McLean's Mountain Wind Farm

**Re: McLean's Mountain Wind Farm - Renewable Energy Approval 7733-8XUNS5
Amendment Application – Condition F1 (3)(c.) Acoustic Audit – Emissions**

Request: This amendment application is to request the deletion of the Acoustic Audit Condition F1 (3)(c.) requirement from the REA permit.

McLean's Mountain Wind Farm Revised (Proposed) Site Plan

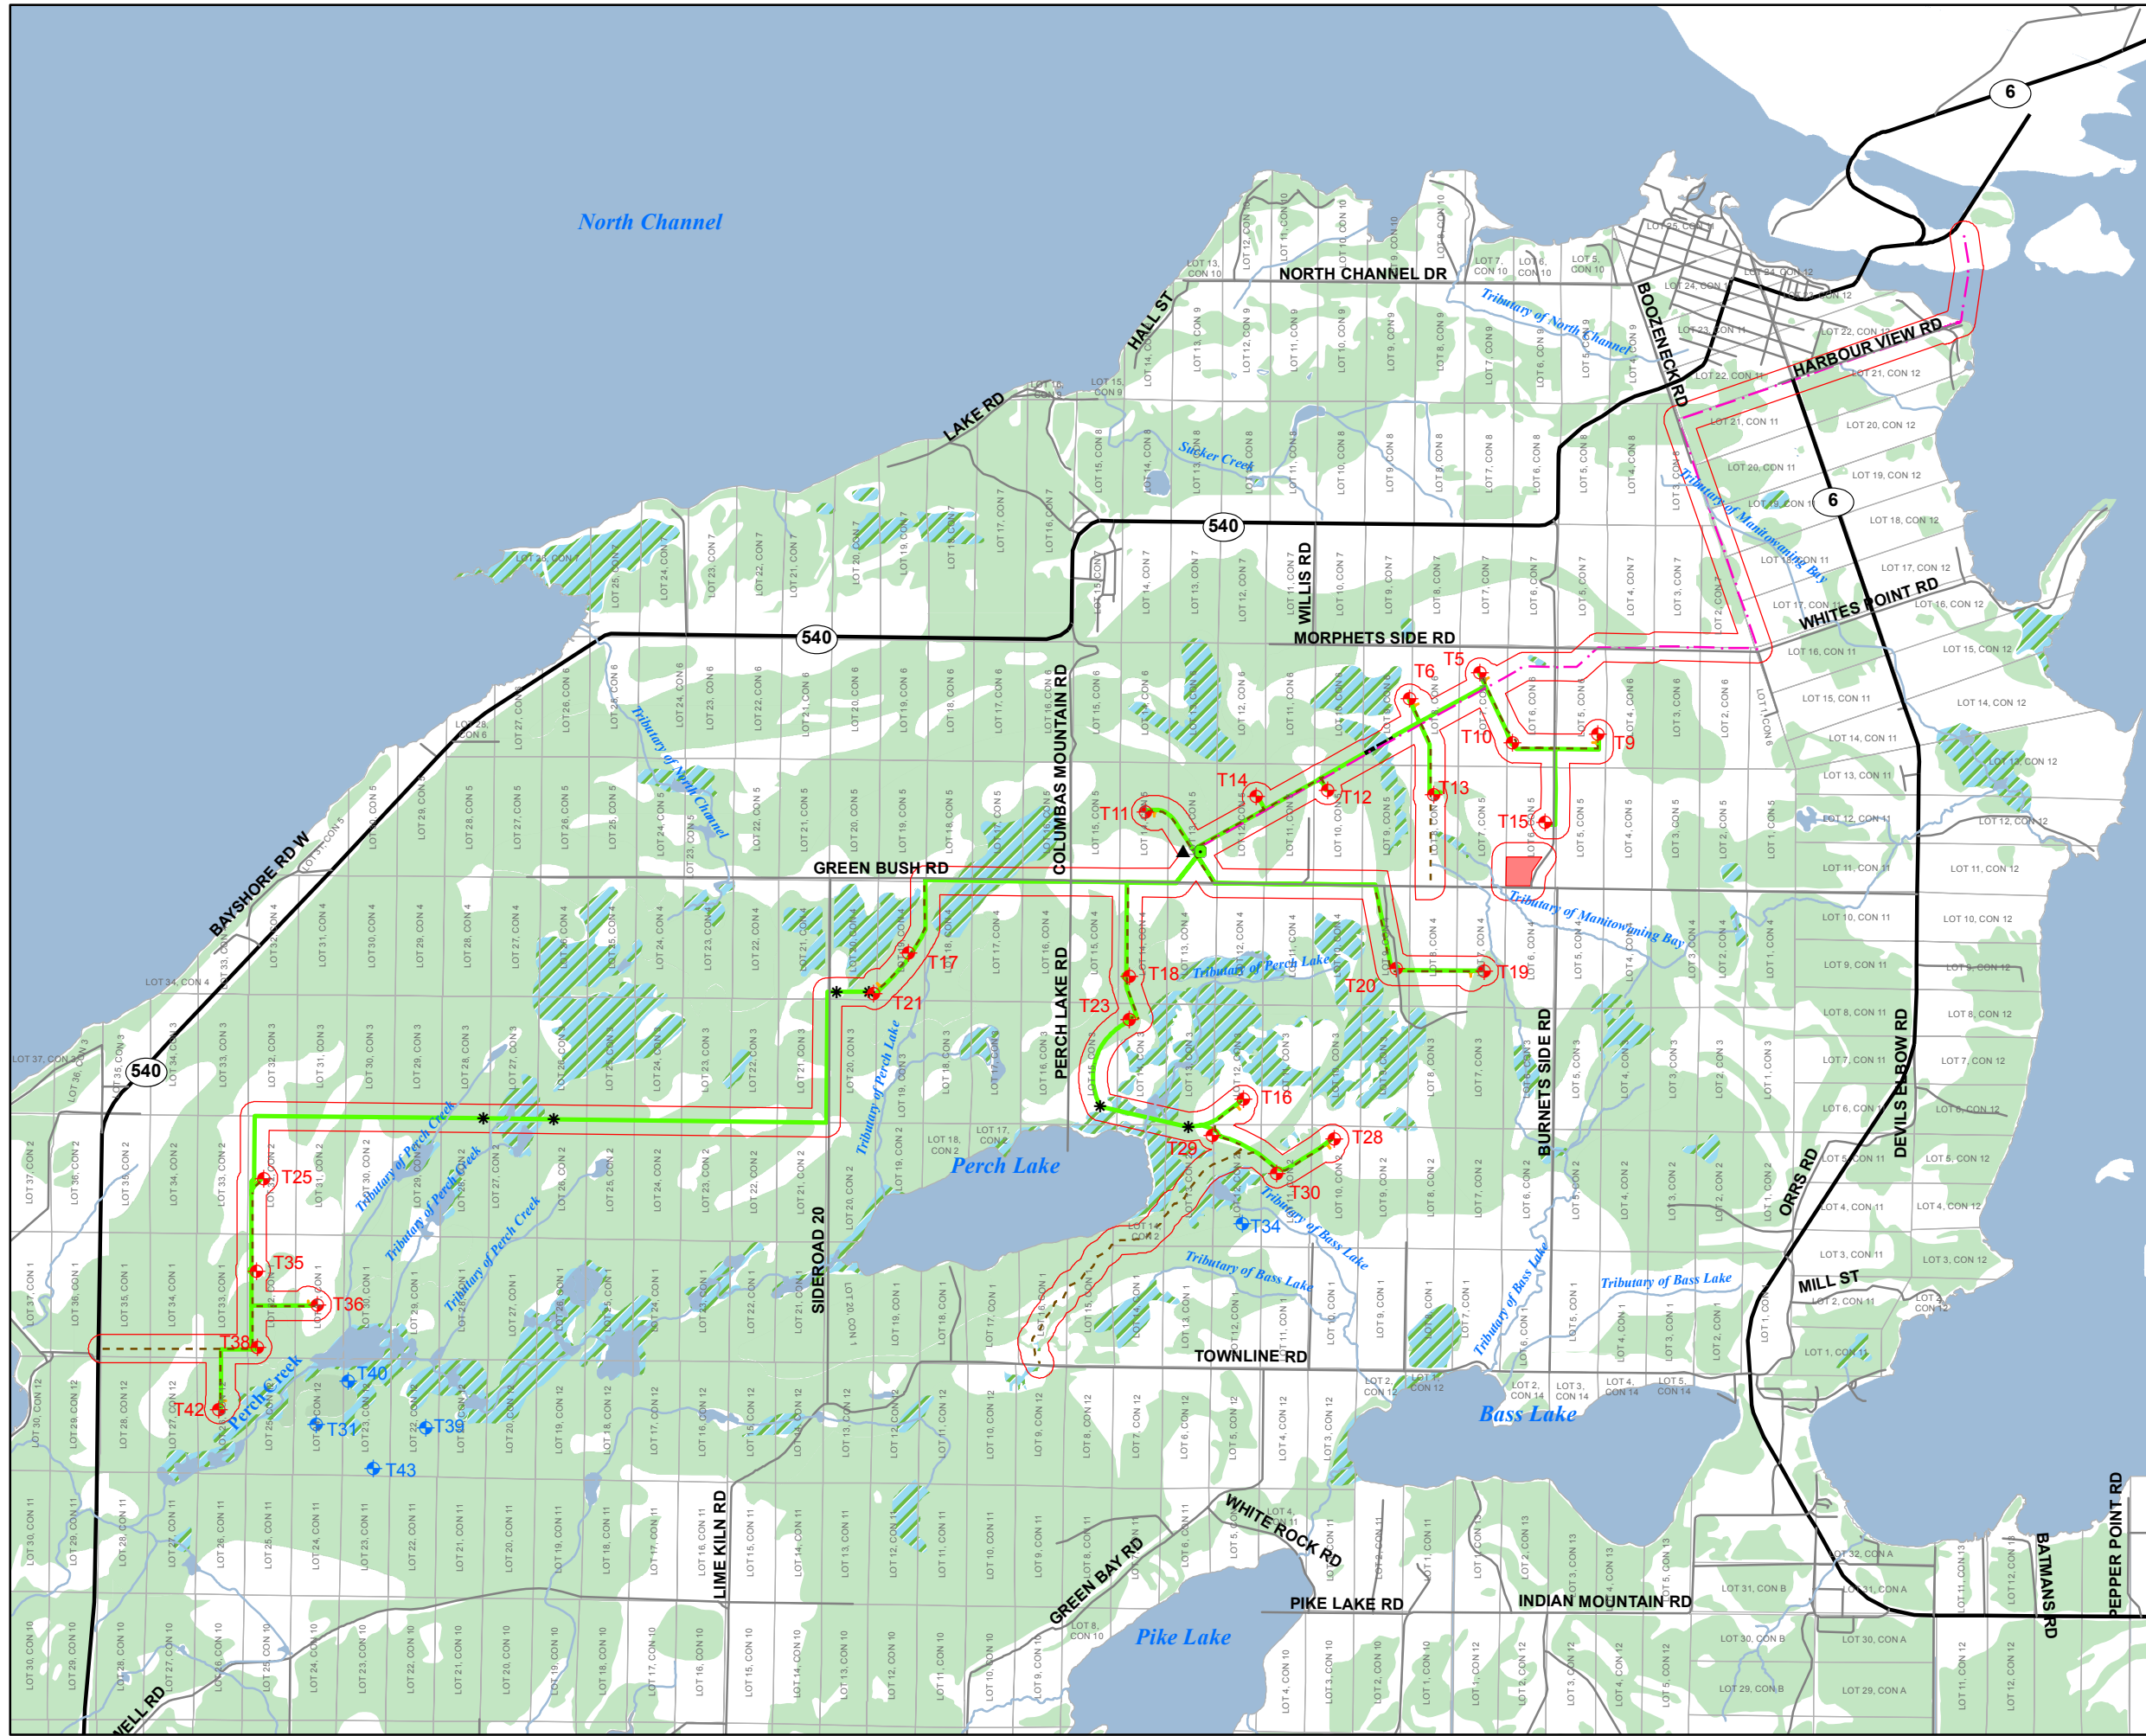
Tab A is the “As built” site plan of the wind farm and T20 is located in the eastern portion of the farm, south of Green Bush Rd, in close proximity to T19. There are few residences near these turbines and it is important to note that we have not received any noise complaints related to the operation of T20 since the start of the facility.
